MXD INFILL DEVELOPMENT CONCEPT PLAN

RESPONSE TO COMMENTS

CAMBRIDGE, MASSACHUSETTS
ISSUED NOVEMBER, 2016

IDCP RESPONSE TO COMMENTS

FIGURE. R1.1.1B

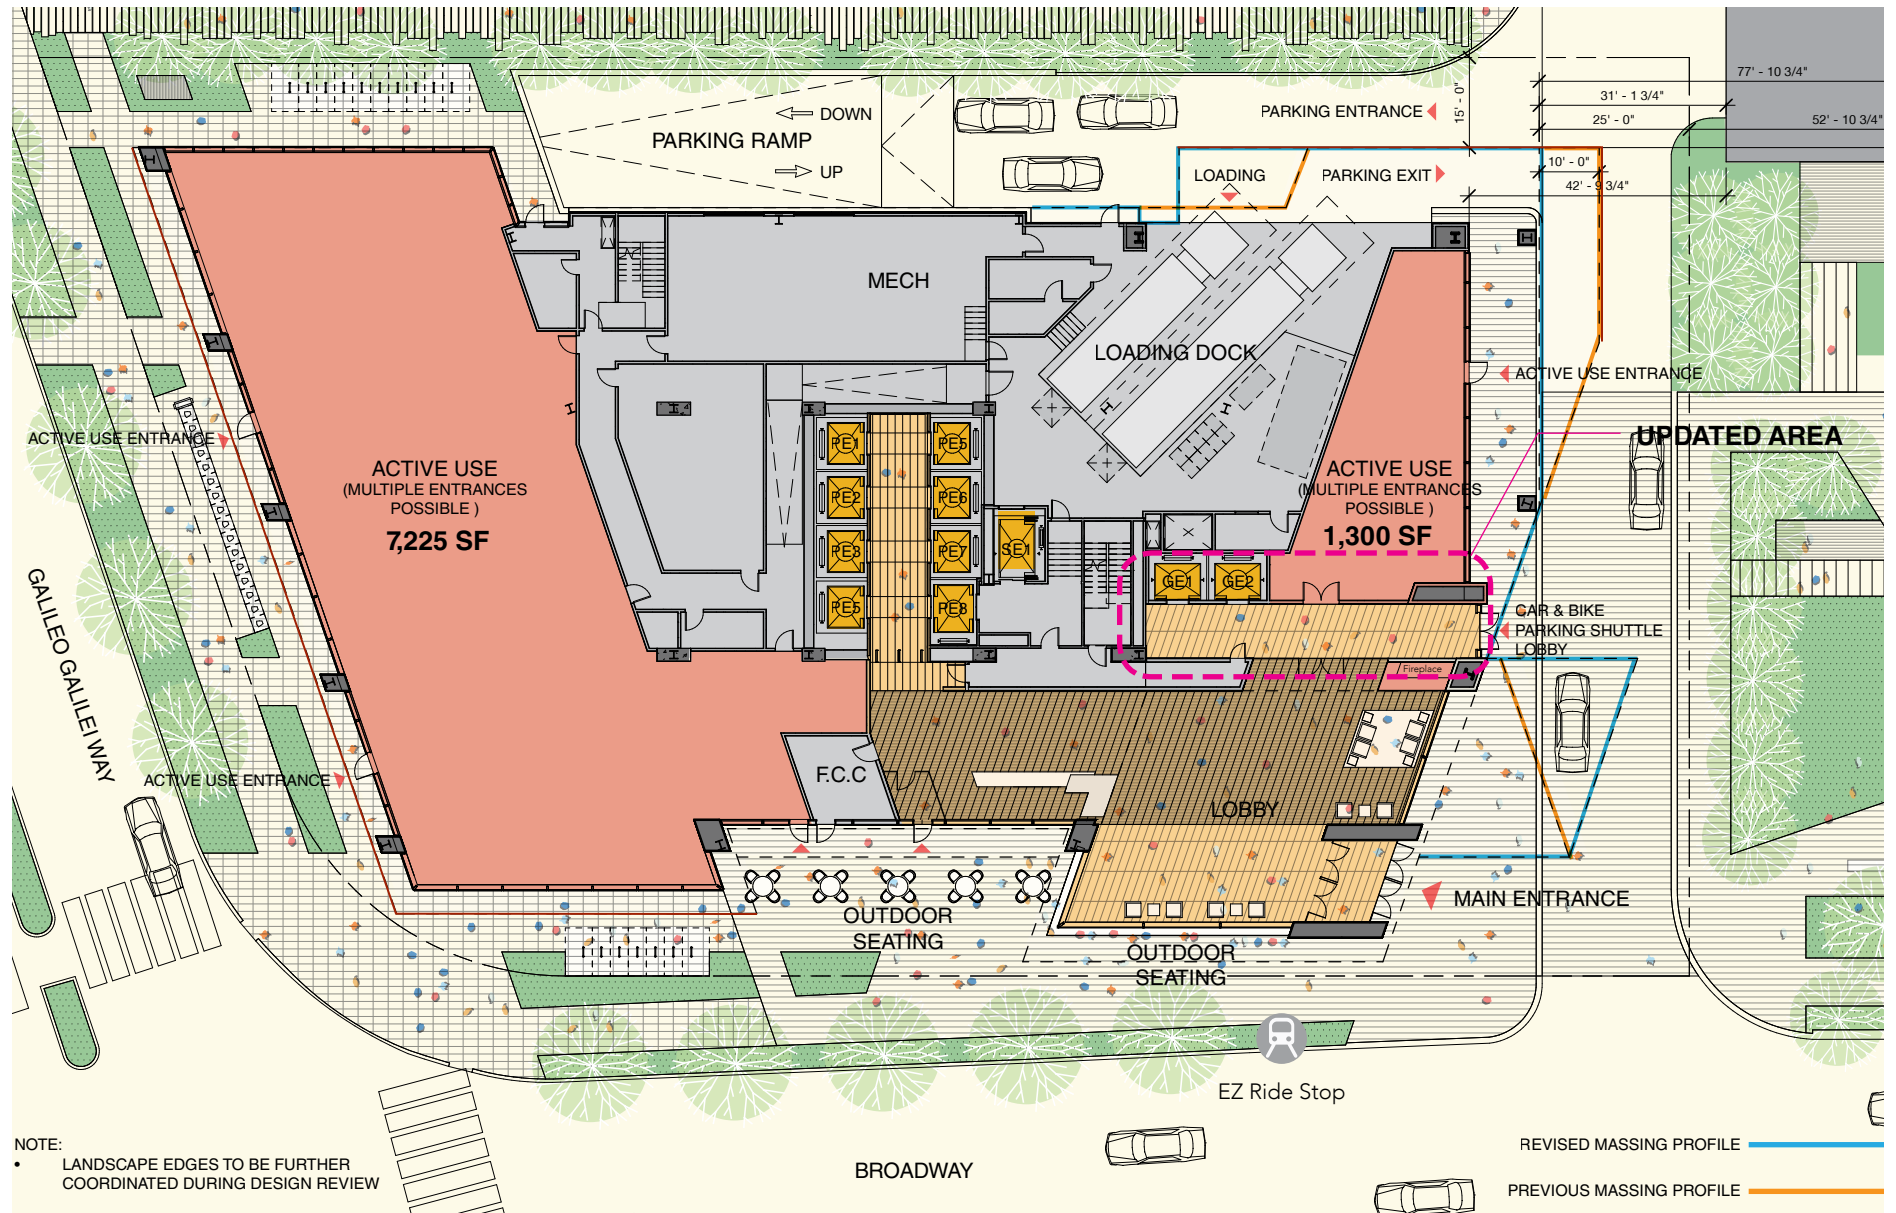
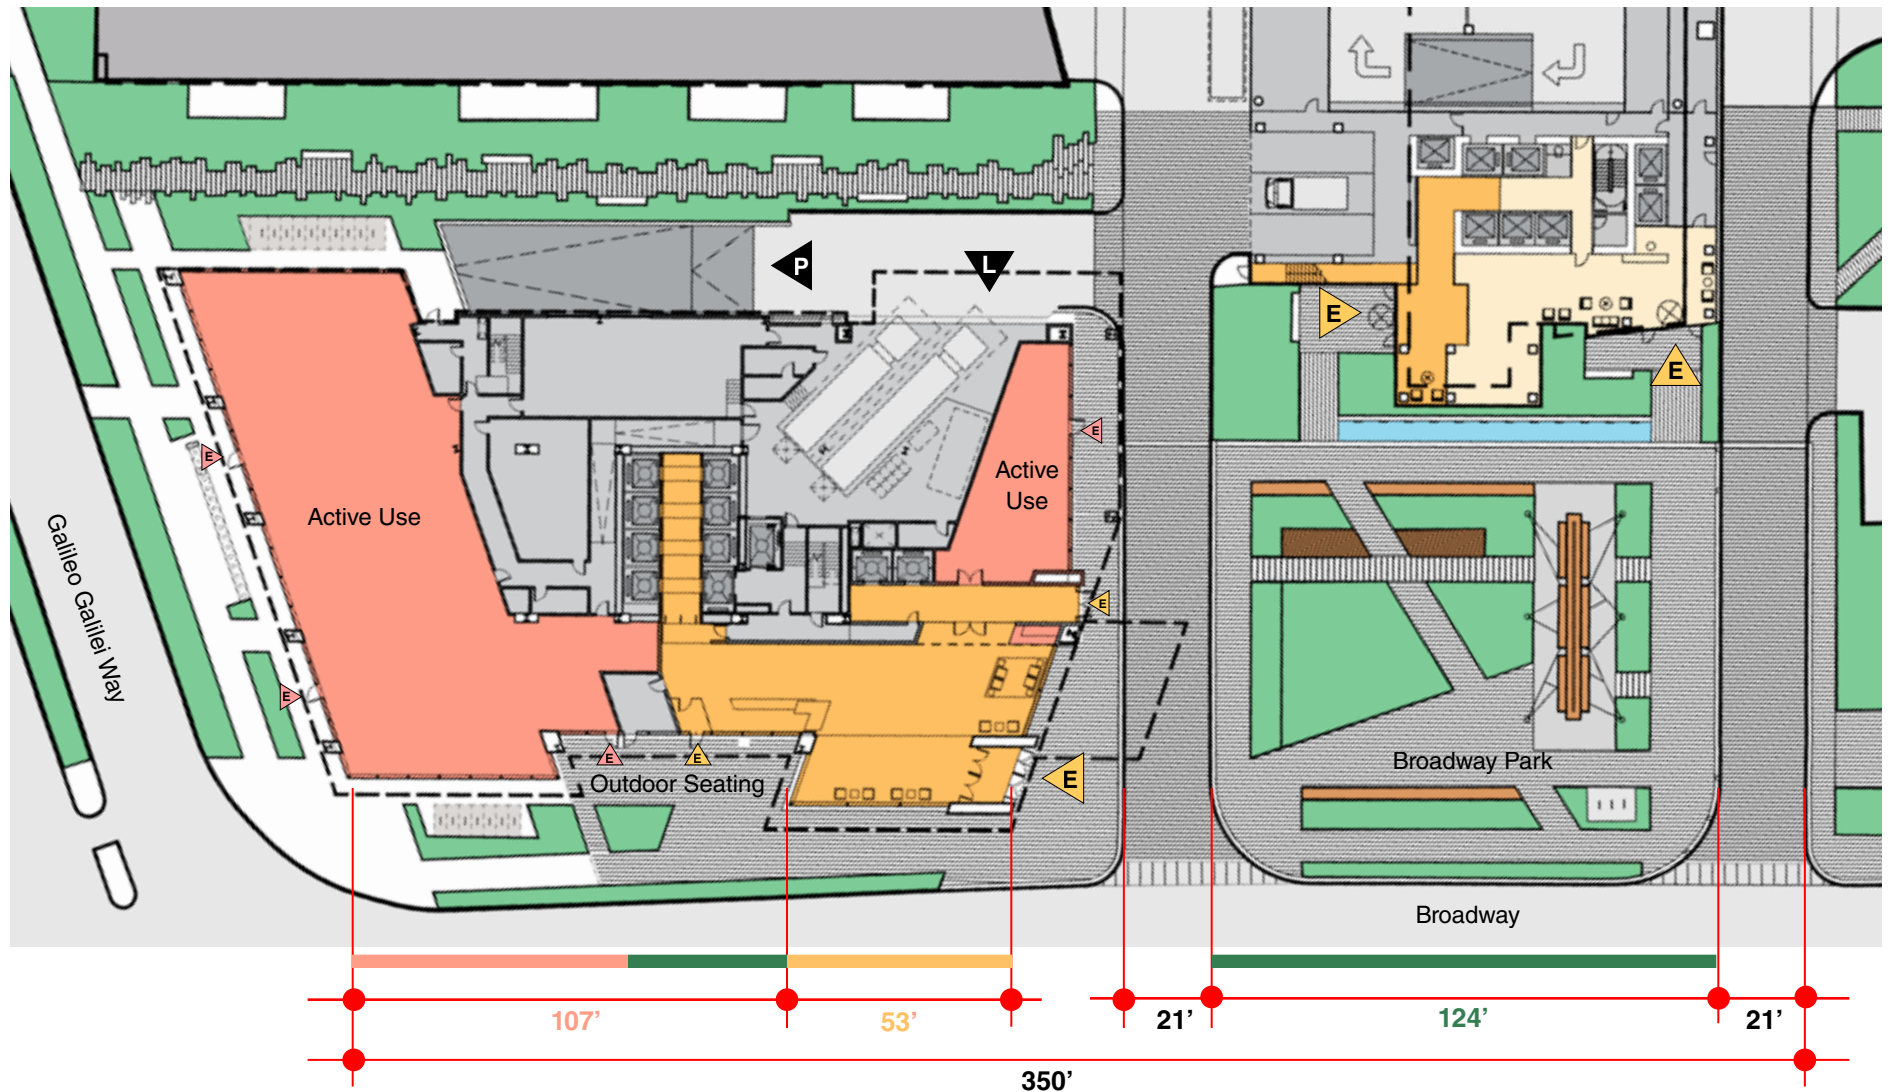
R1.1.1 RETAIL AND ACTIVE USE IN LOBBY: Applicant received several comments and questions about the configuration of the lobby, retail and active use space. The lobby entrance is designed to be oriented toward the corner of Broadway Park both to provide an active use element and to provide further strength to the concept of reconfiguring Broadway Park as an open plaza that connects the entrances of 145 Broadway, 105 Broadway and the South Residential Tower as shown in **FIG. R1.1.1A**, ensuring an active plaza, all times of the day. An updated ground floor plan for 145 Broadway that relocates the garage shuttle elevators to the interior of the building **FIG R1.1.1B**. The result is increased glass line along the park for the northeast retail suite. In addition, the plan provides for outdoor seating along Broadway to increase the active use edge percentage from the 68% detailed in the MXD IDCP August 09, 2016 submission to 75% see **FIG. R1.1.1C**. The retail will be designed with flexibility to ensure multiple options for entrances to accommodate various uses and potential demising plans. **FIG. R1.1.1C** Represents the concept plan's active frontage on Broadway being Retail and Consumer Services or Active Public Gathering Space for a cohesive response to the proposed developments and the public realm

COMMERCIAL BUILDING A (145 BROADWAY): MASSING AND CANTILEVERS

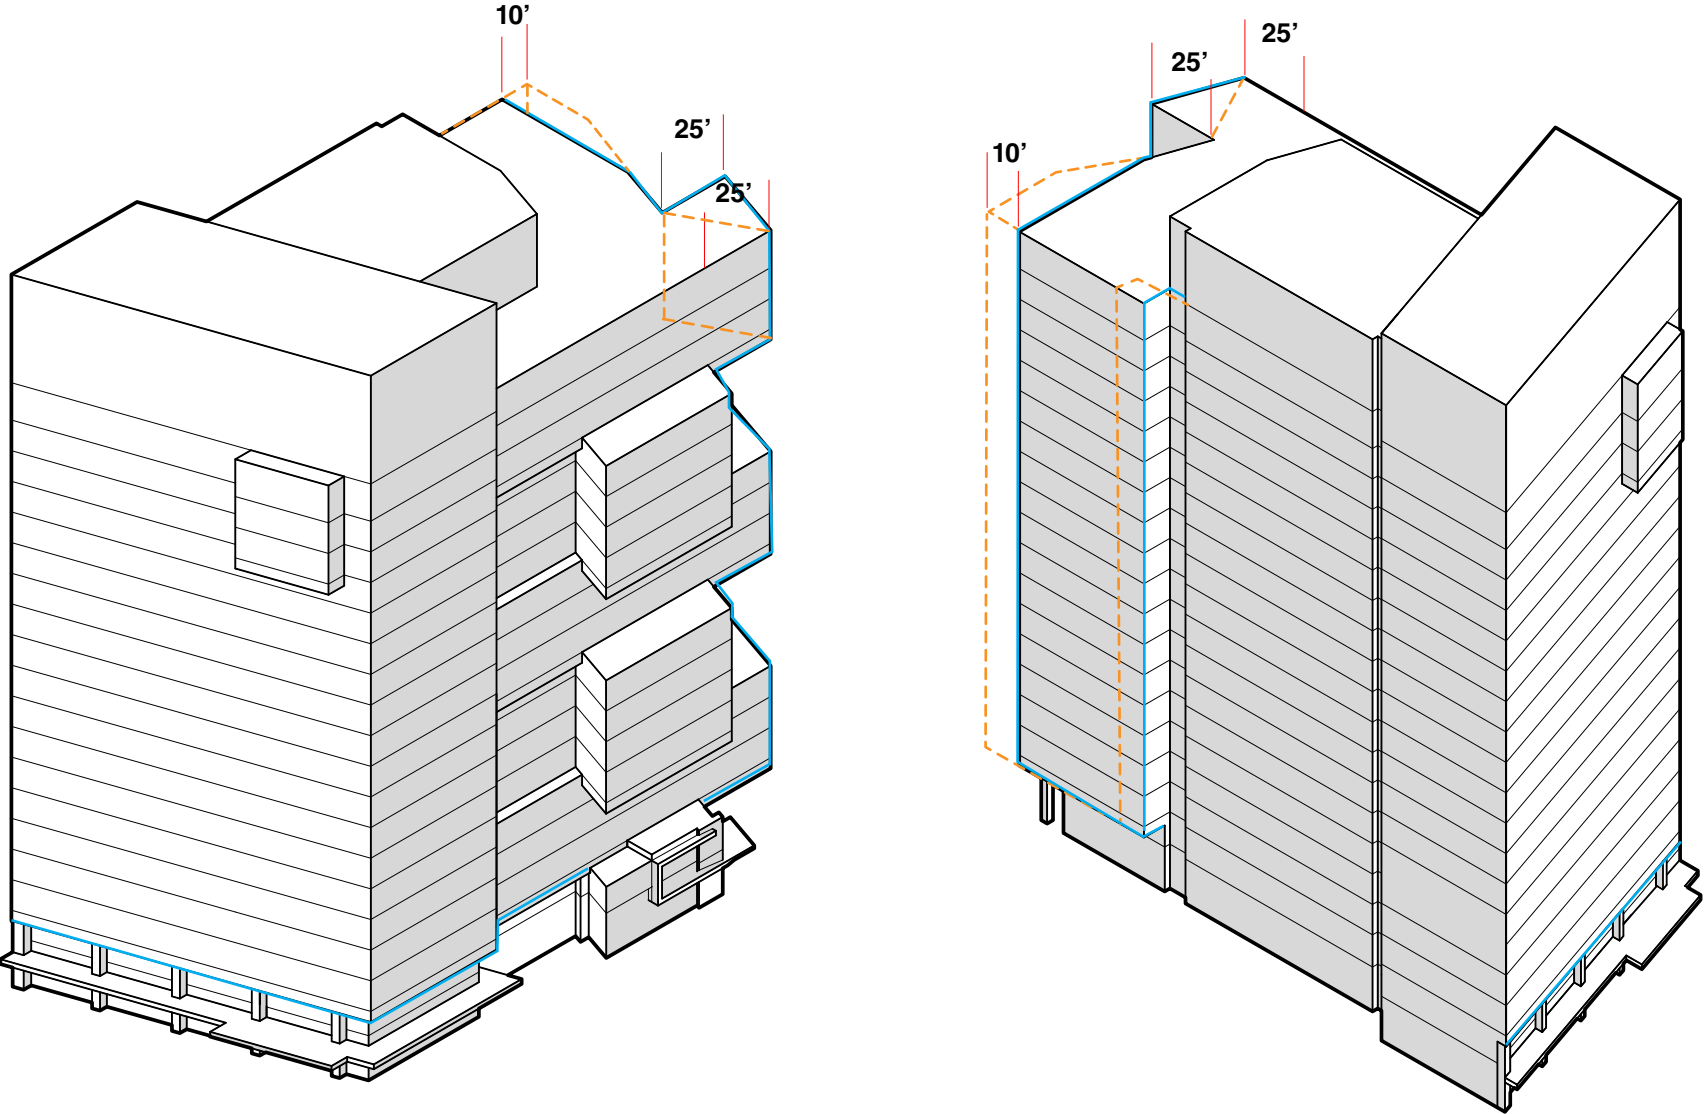
R1.1.3 MASSING AND CANTILEVERS: Applicant received comments about the impact of the 145 massing and cantilevers on the western service drive and Broadway Park. Applicant has made active efforts to ensure 145 Broadway is not only designed to ensure internal usability and flexibility but is also visually interesting from the street with multiple expansions and contractions. In addition, the design as proposed provides a distinctive and interesting approach to the scaling goals that are part of the K2 datum height and podium guidelines. Applicant has reviewed the proposed massing in the context of creating a functional and interesting building, along with K2 guidelines and concerns over cantilevers expressed in the comments. **FIG. R1.1.3A** and **FIG. R1.1.3B** shows a massing that reduces the cantilevers along the western service drive by 10 feet, reorients the southeast cantilevers towards the street to create visual connection and still maintains the interest and scaling inherent in the original design intent.

FIGURE. R1.2.1

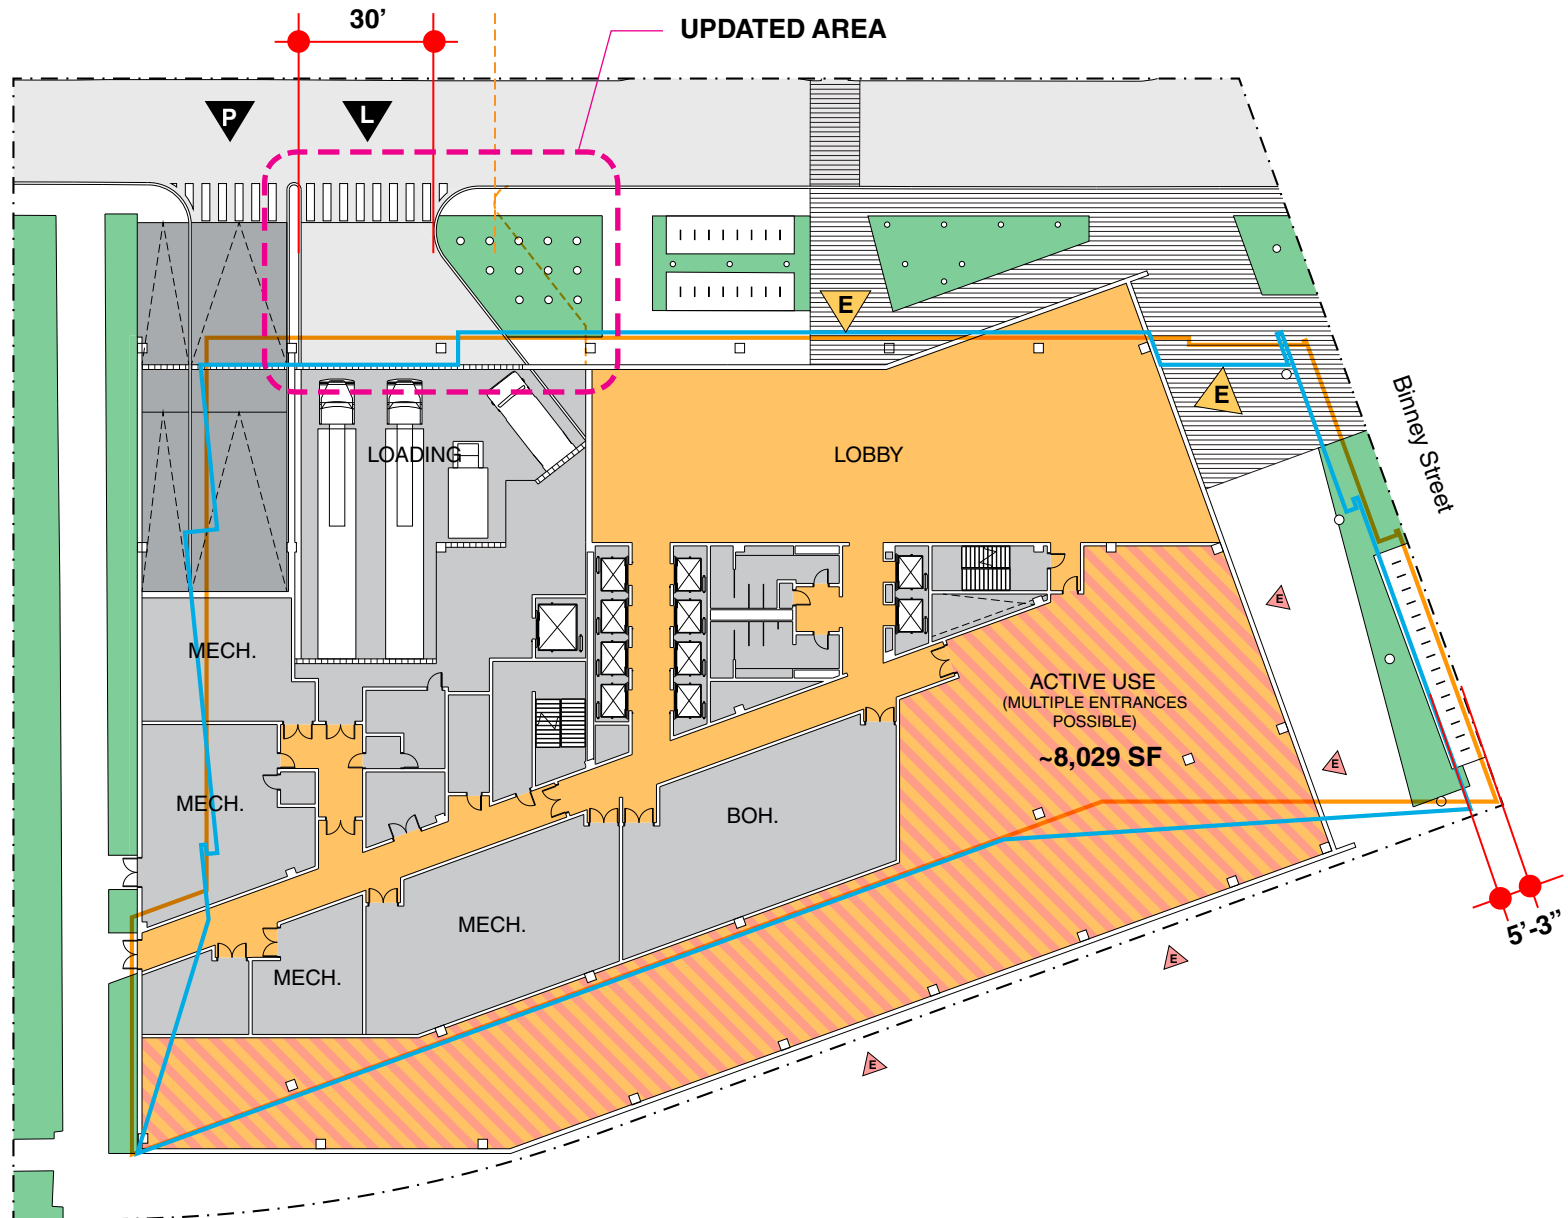
R1.2.1 FLOOR PLATE SIZE: Applicant has received comments regarding the size of the floor plates at of 250 Binney Street. The 250 Binney building is being designed to support programmatic flexibility for both potential office and laboratory tenants. In the current market context, both within the Kendall Square submarket and the broader Boston market, many creative and technology firms are seeking large, open floor plates in order to foster connectivity and communication between their workforce and ease of configuration for a variety of space planning possibilities. The typical floor plate at 250 Binney Street is targeted at 30,000 Gross Square Feet, which is consistent with current market demand. The floor plate is also a product of efficient and effective core to exterior wall dimensions that foster the kind of programmatic flexibility necessary to be competitive in the market and attract excellent long-term tenants.

R1.2.4 LOADING DOCKS: CDD staff has noted that the curb cut at the loading dock is wider than the 30' recommended by K2. The loading dock has been thoughtfully located at the interior most corner of the site, off of the internal service drive, which protects it from view from the public streets. It is located directly adjacent to the garage access, so that the impact of these two uses on the overall façade and pedestrian experience can be minimized as much as possible. The design will include loading dock doors and additional design measures have been implemented to minimize its visual impact along the service drive, such as recessing it from the primary façade and forming the streetscape to minimize the curb cut as much as possible. A buffer has been added between the garage entry and the loading dock and the curb cut has been narrowed to 30' by extending the sidewalk zone further south and angling the drive leading to the loading dock. **FIG. R1.2.1**
